Re: Patlilly Subdivision Drainage Report

I have reviewed the drainage report for the Patlilly Subdivision and I can't grant approval because of the following considerations:

PATLILLY SUBDIVISION

PATLILLY SUBDIVISION
(A Townhouse Development)

EXISTING FLOW ROUTES ③
SEE ORTHOPHOTO SEGMENT INCLUDED

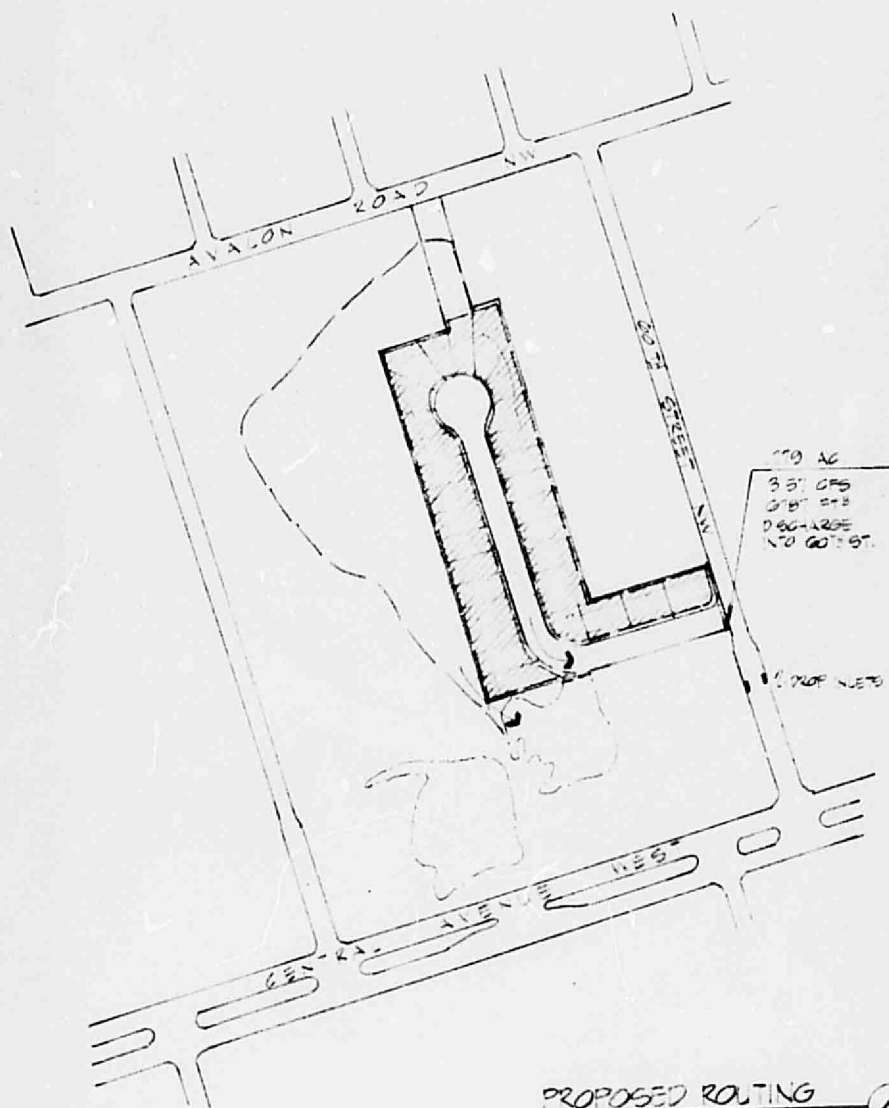
2. Even though the report recognizes the existence of offsite flow, generated by the 2.31 Ac. immediately to the west of this subdivision, no indication is furnished on how the runoff from this land will be handled. The only indication supplied consists of an arrow on Exhibit 3 showing a diversion of the offsite flow around the subdivision and onto the depression to the south. Exhibit 2 shows unequivocally that the runoff generated by the 2.31 Ac. west of this property enters Patlilly Subdivision; this condition must be preserved.

2. Preserve to the greatest possible extent the existing ground configuration, allowing the offsite runoff to enter this parcel as it occurs today.
